* * * * *
 *
 * UNITED STATES *
 * DEPARTMENT OF THE INTERIOR *
 * BUREAU OF RECLAMATION *
 *
 * - - - *
 * HYDRAULIC LABORATORY REPORT NO. 32 *
 *
 * - - - *
 * MODEL STUDIES OF DOS BOCAS DAM SPILLWAY *
 *
 * BY *
 * J. E. WARNOCK and J. H. DOUMA *
 *
 * - - - *
 * Denver, Colorado *
 *
 * February 28, 1938 *
 *
 * * * * *

Guayama, Puerto Rico
November 20, 1937.

Reference is made to your letter of November 20, 1937, and office letter of November 30, 1937, concerning model studies of the Dos Bocas Dam spillway.

**ELEVATION THROUGH LINE OF PIEZOMETERS
SHOWING**

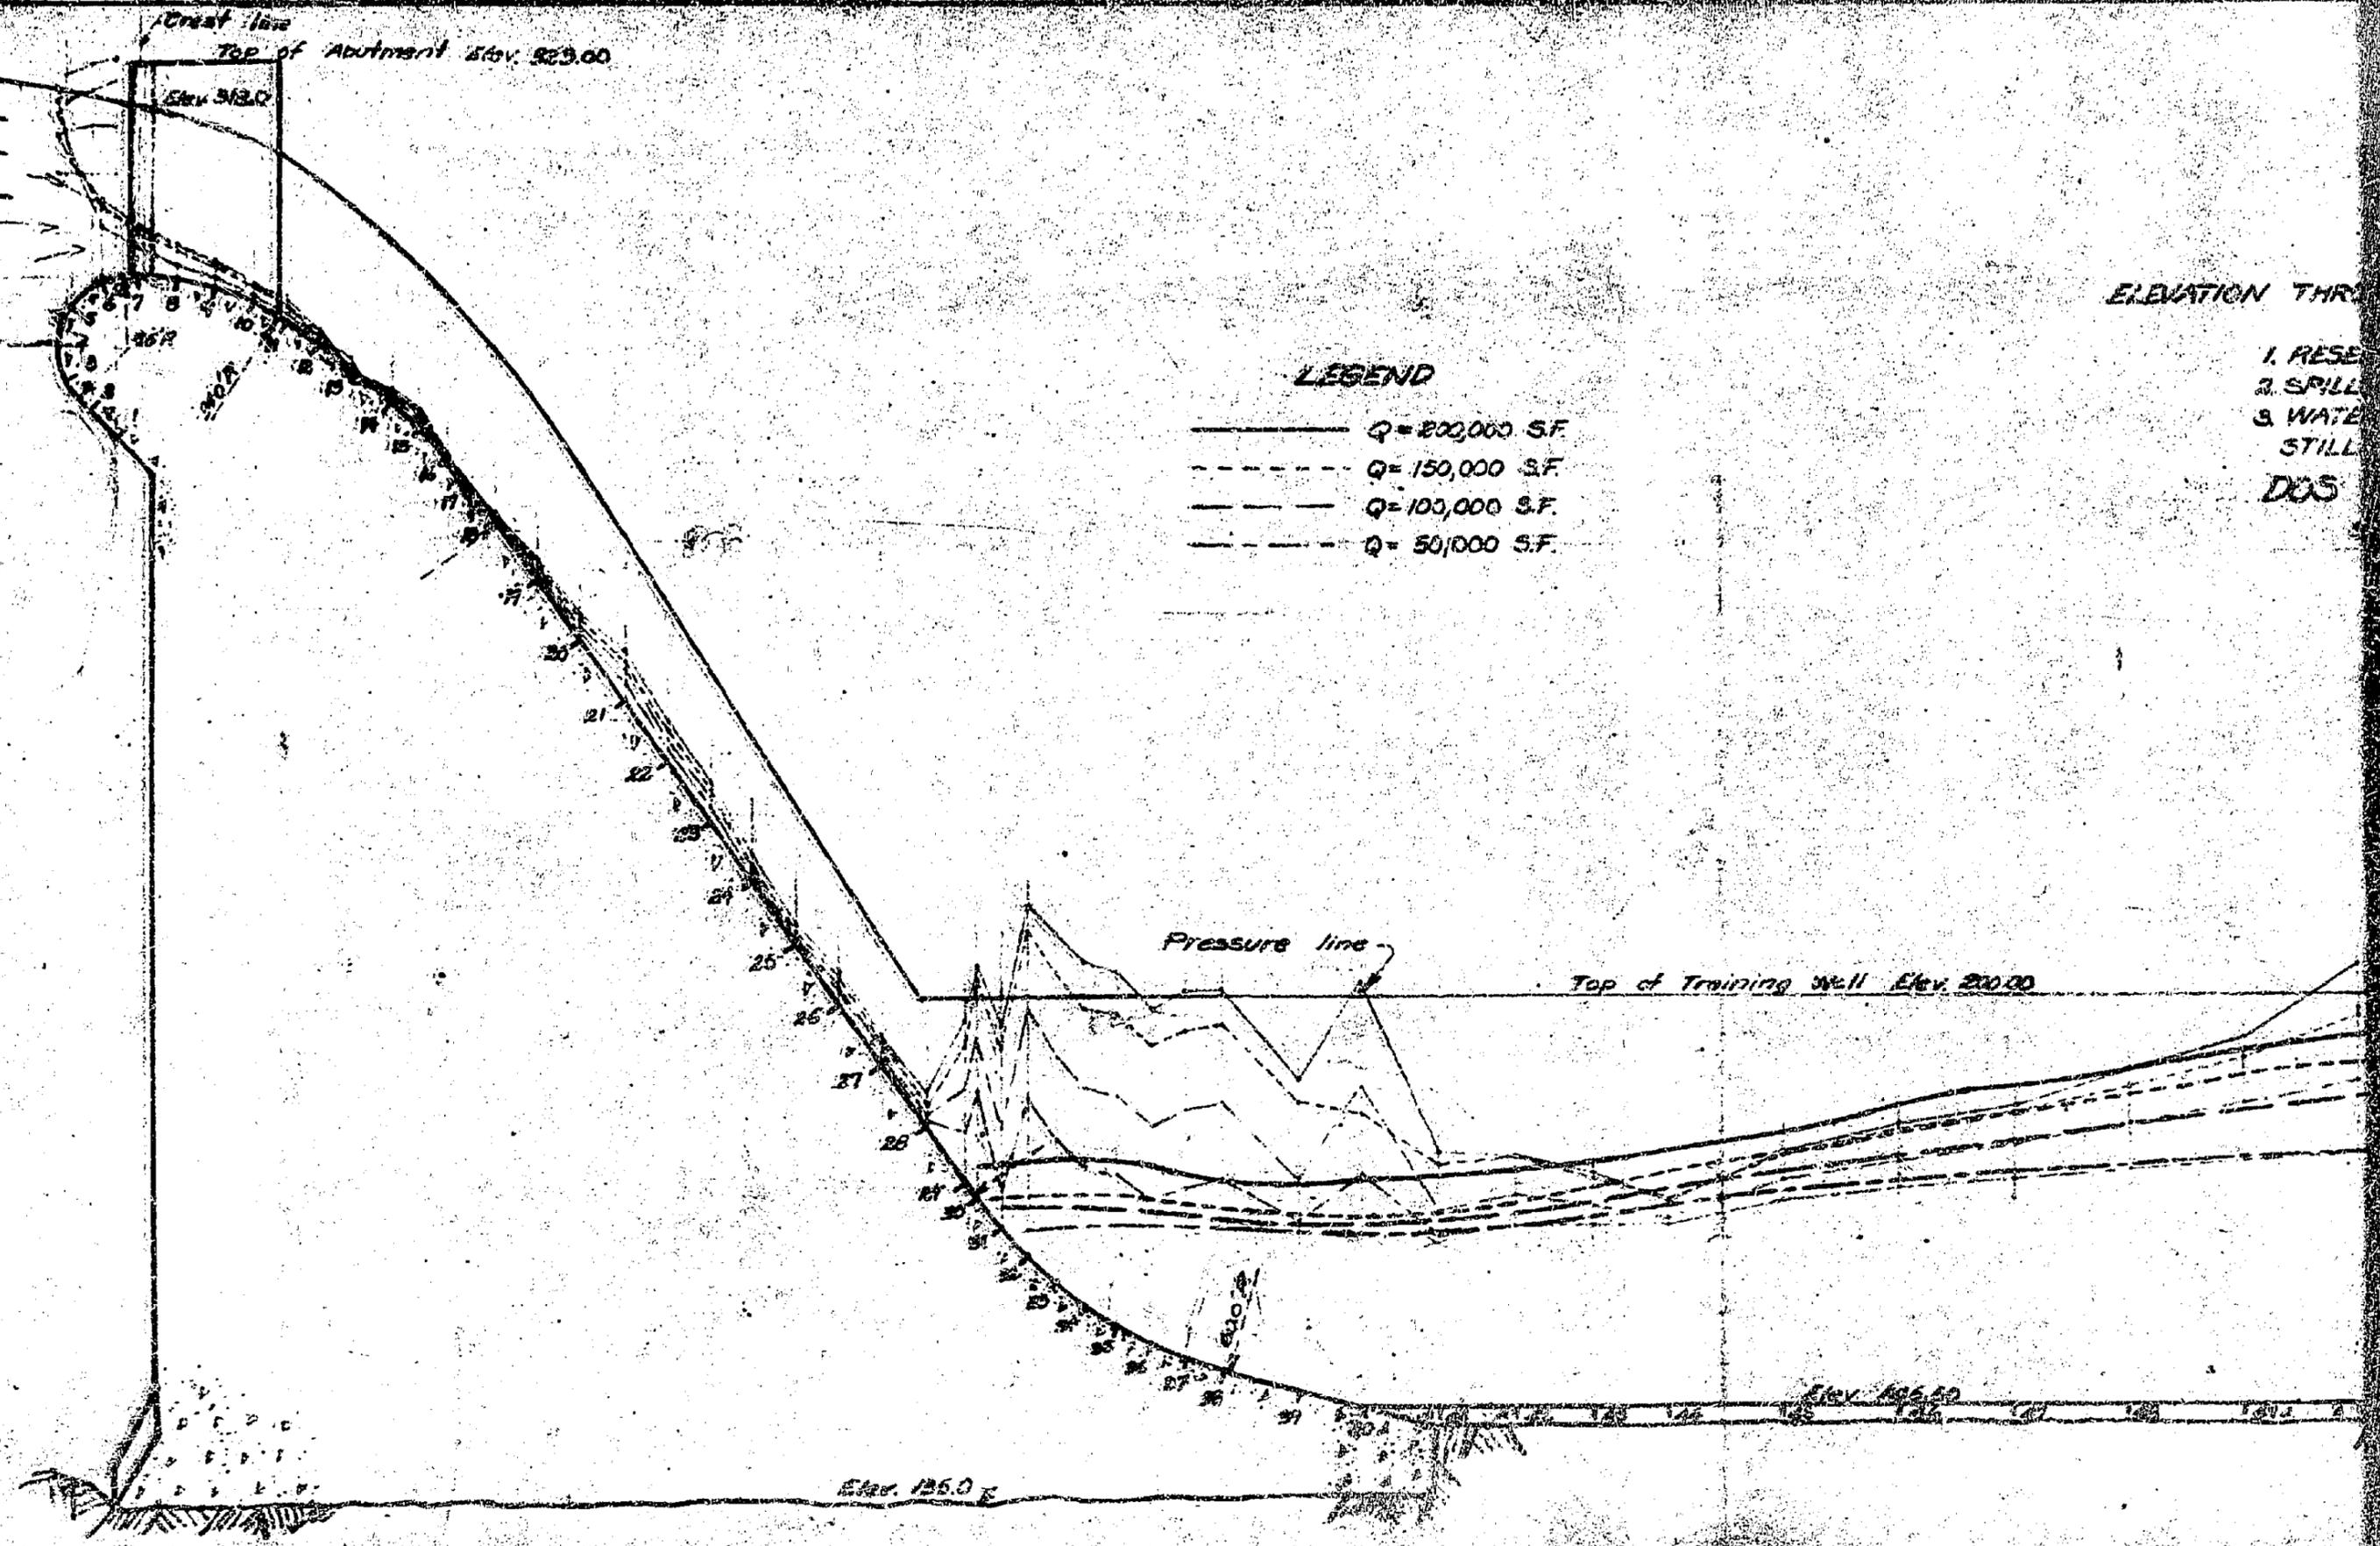
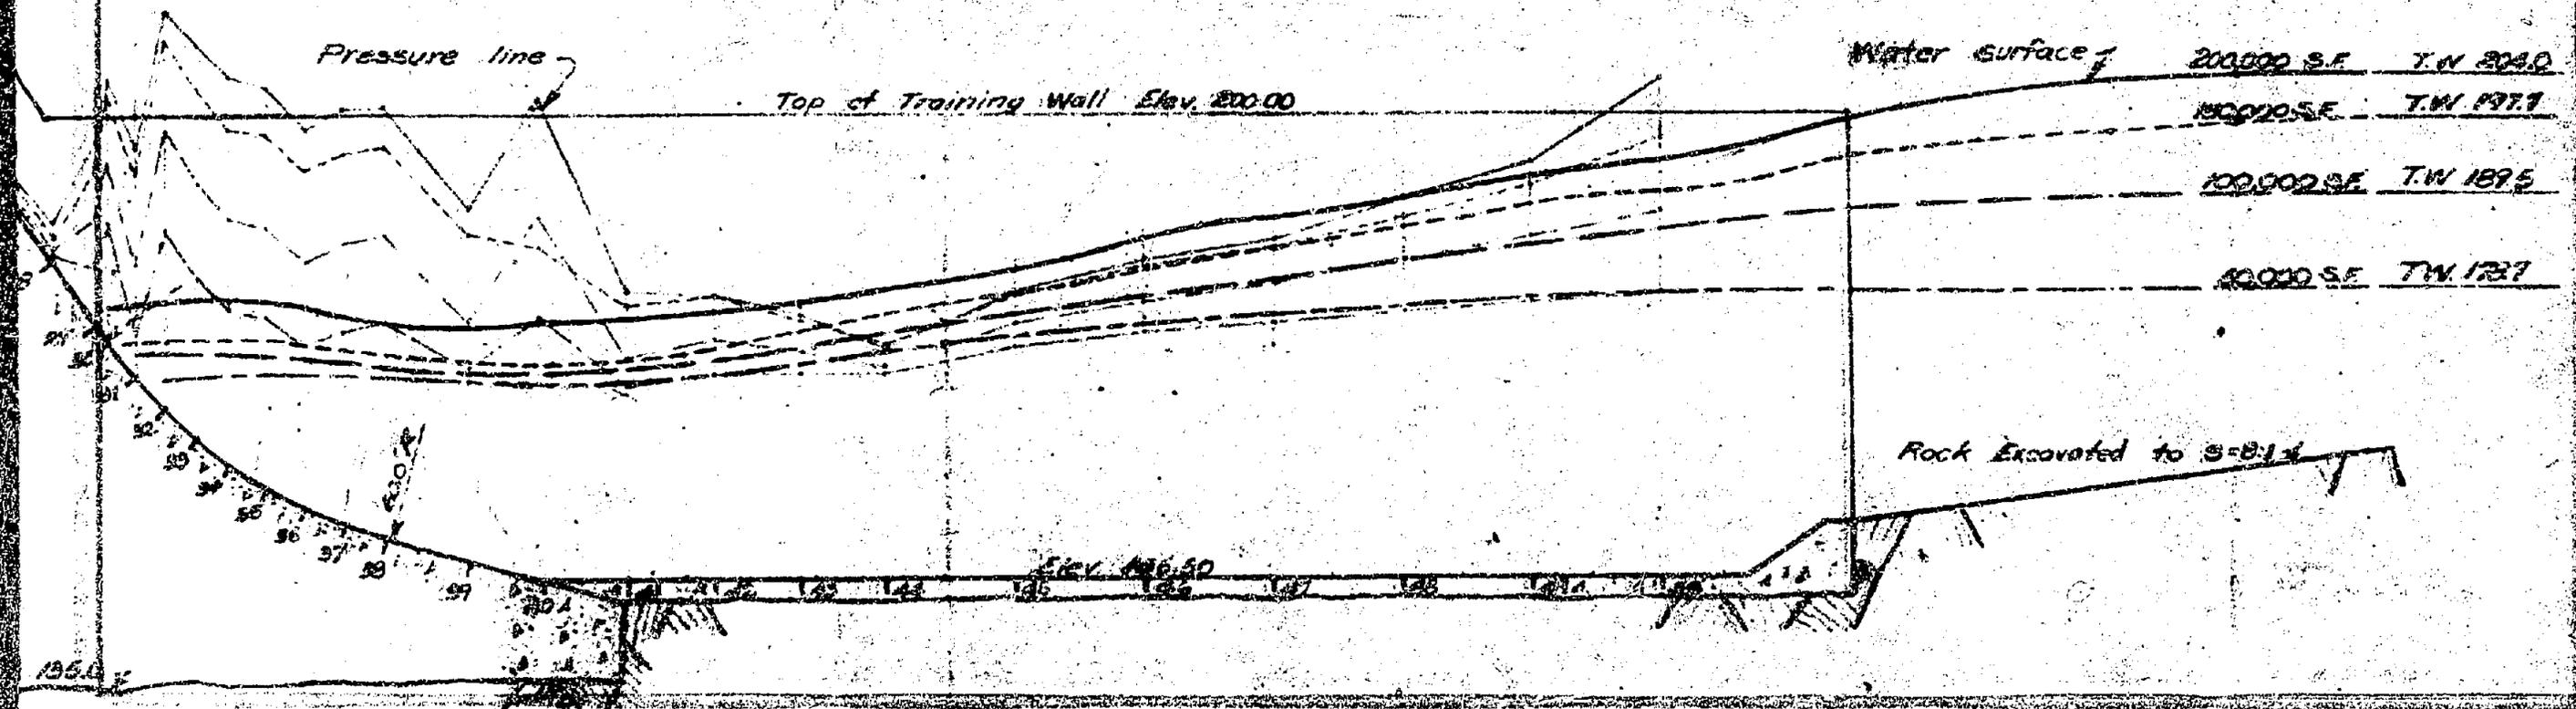
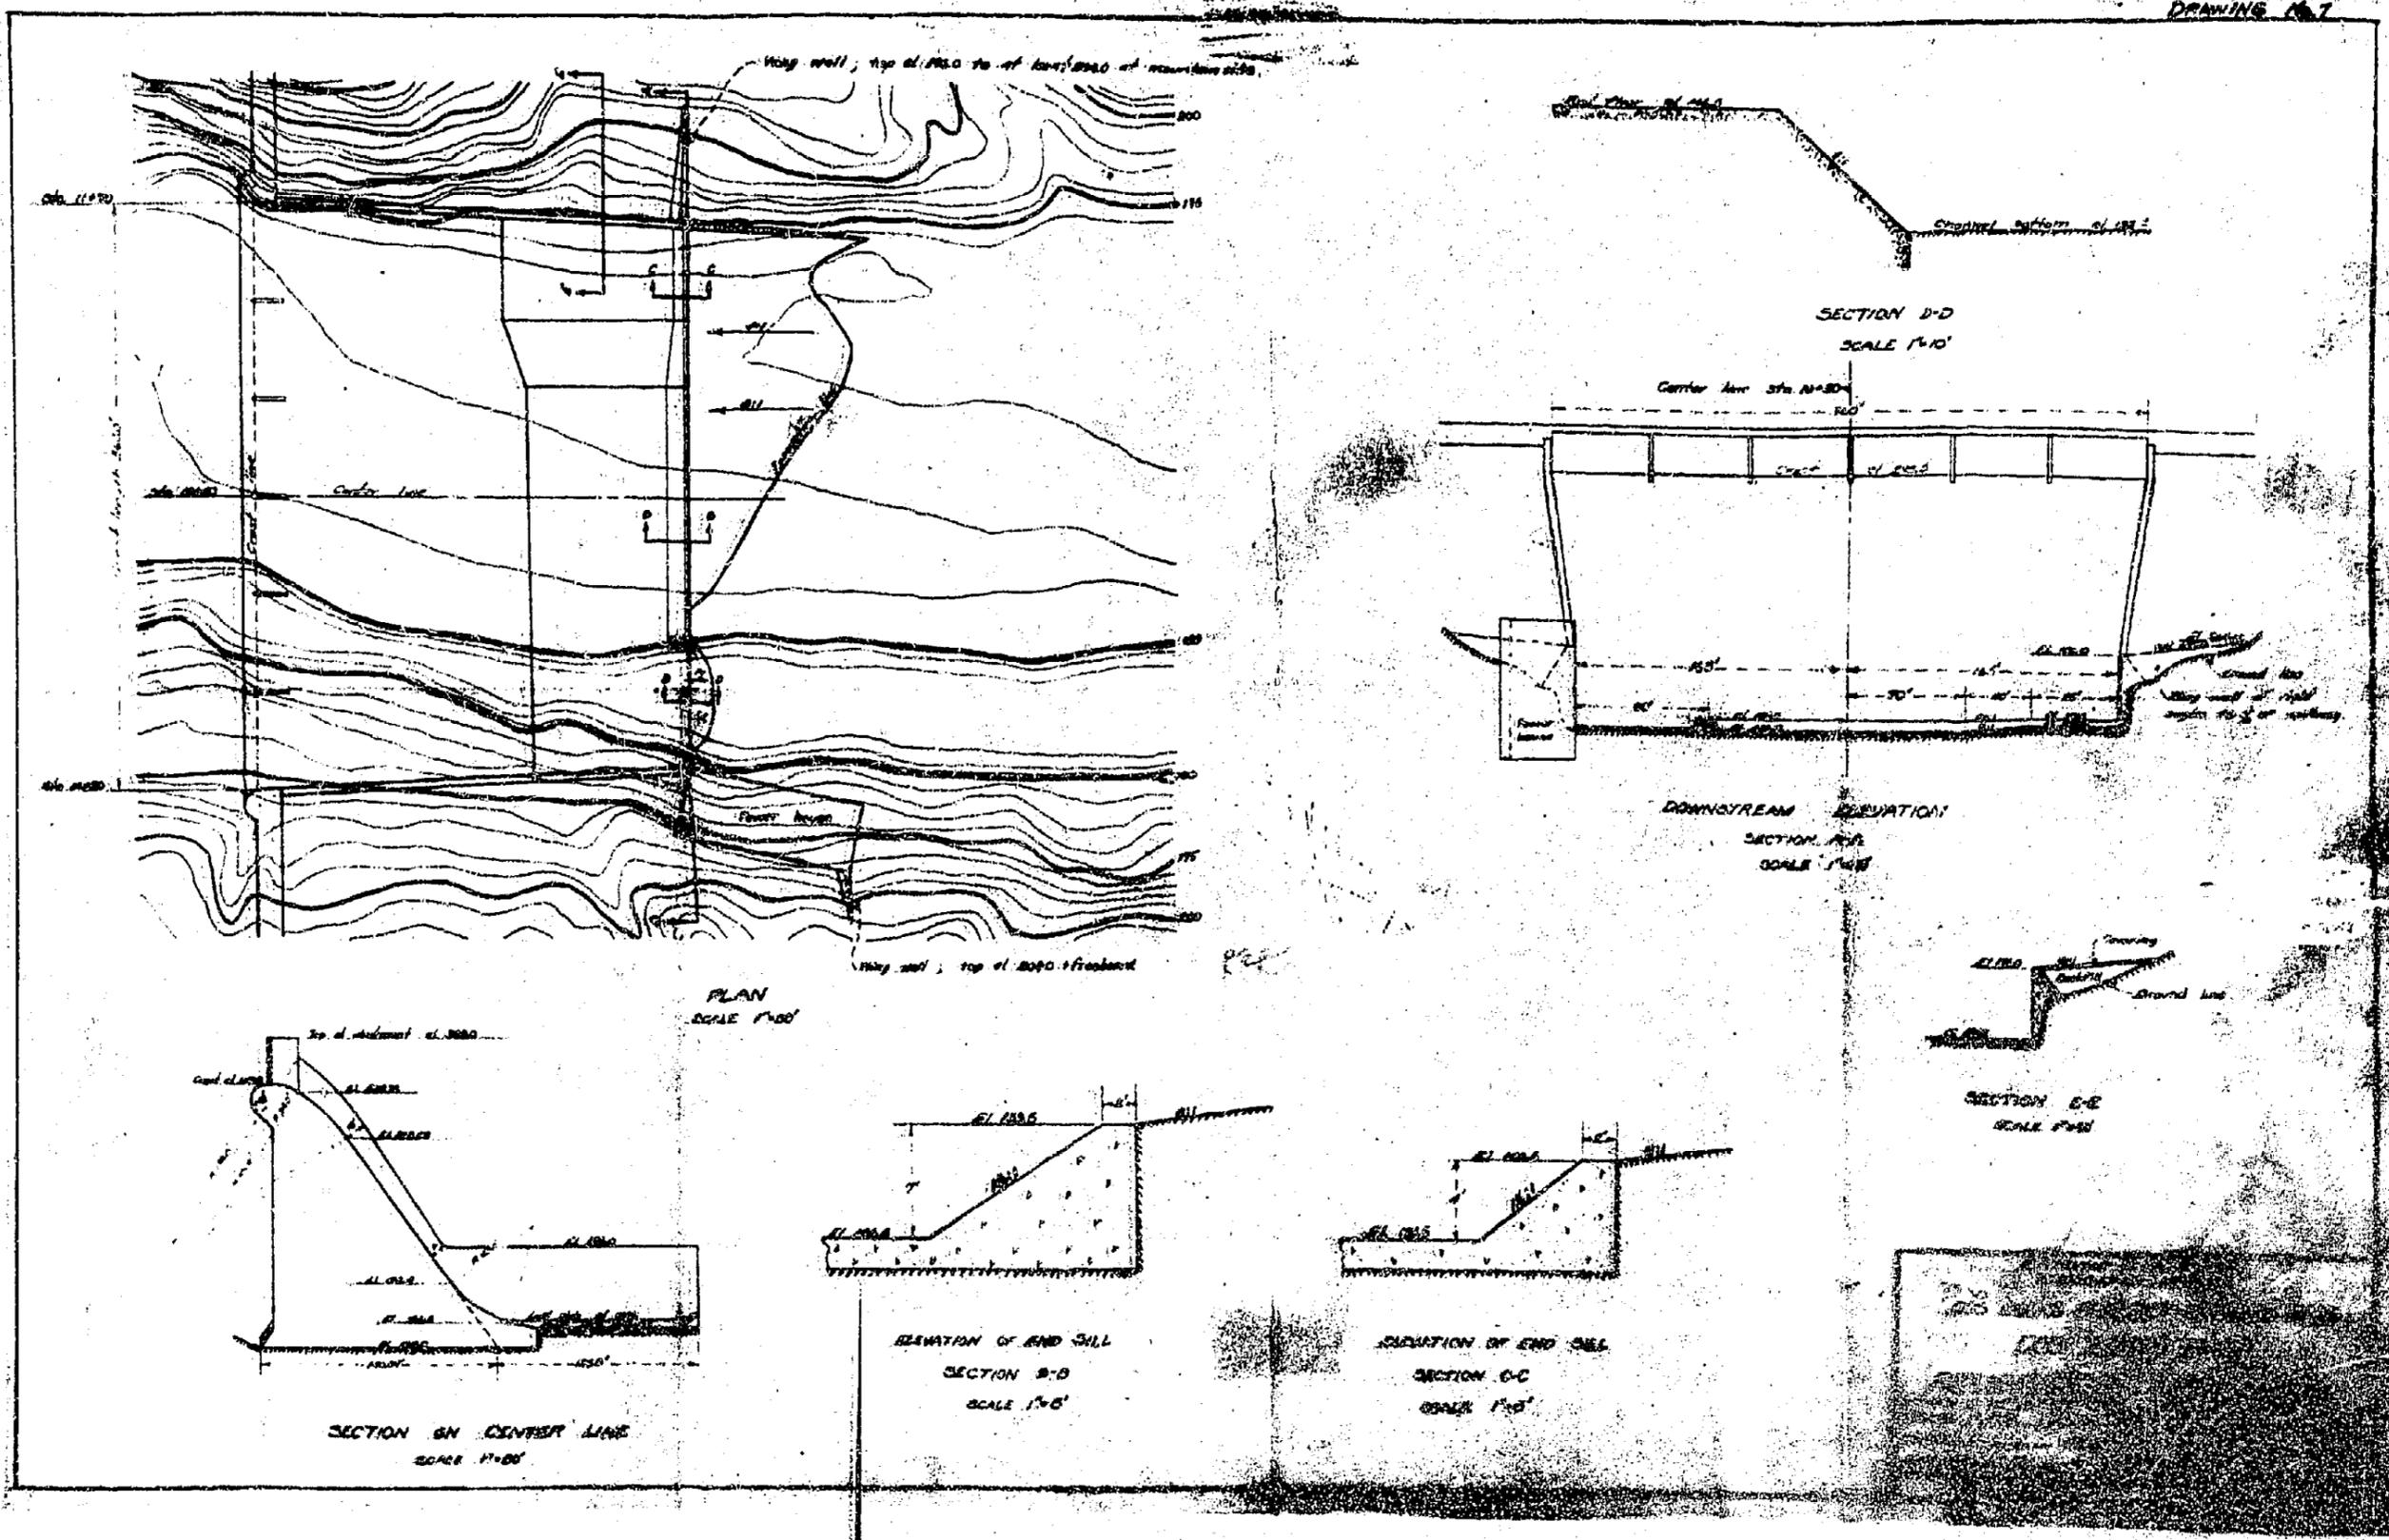
150,000, and 200,000 second-feet are shown on drawing No. 6. The piezometers (drawing No. 1) are located on a line 150 feet from the left wall. Piezometers 1 to 5, inclusive, show some pressure of impact due to velocity of approach. Small negative pressures are shown by piezometers 13, 16, and 17. The maximum negative pressure is 2.5 feet (prototype) at piezometer 17 for the discharge of 200,000 second-feet. High pressures due to centrifugal action are shown at the entrance to the stilling basin. Beyond the region of centrifugal action the pressures conform closely to the corresponding water depths.

Stilling basin. The original stilling basin design was tested for discharges of 50,000, 100,000, 150,000, and 200,000 second-feet. Mean water surface profiles through the jump are shown on drawing No. 6. The tailwater for each discharge was determined from the tailwater height curve for the Arecibo River at Dos Bocas Damsite furnished with your letter of November 20. Plates 4B, 5B, and 6B show the pool action for 200,000 second-feet with the revised design of the spillway crest entrance. An excellent hydraulic jump exists over the high-level floor, but on the right side a very turbulent boiling action occurs over the end sill in line with the lower river channel. The combined action of a large ground roller in the deeper river channel behind the end sill and the action of the high end sill on this side gives the water flowing downstream on the stilling basin floor an excessive upward component of velocity resulting in the unfavorable boiling. This may be remedied by decreasing the sill height on this side, or if this results in strong cross-currents due to the varying apron elevation, an apron sloping about 4:1 from the top of the sill to the channel bed may prove effective. The jump is satisfactory over most of the basin for a discharge of 150,000 second-feet (plate 9B) and the boiling on the right side is less serious but the condition still exists. The hydraulic jump is appreciably shorter for a discharge of 100,000 second-feet and most of the energy is dissipated before the end sill is reached so no boiling action is present (plate 10A) and a good jump exists over the entire basin. A peculiar condition exists with a discharge of 50,000 second-feet which can be
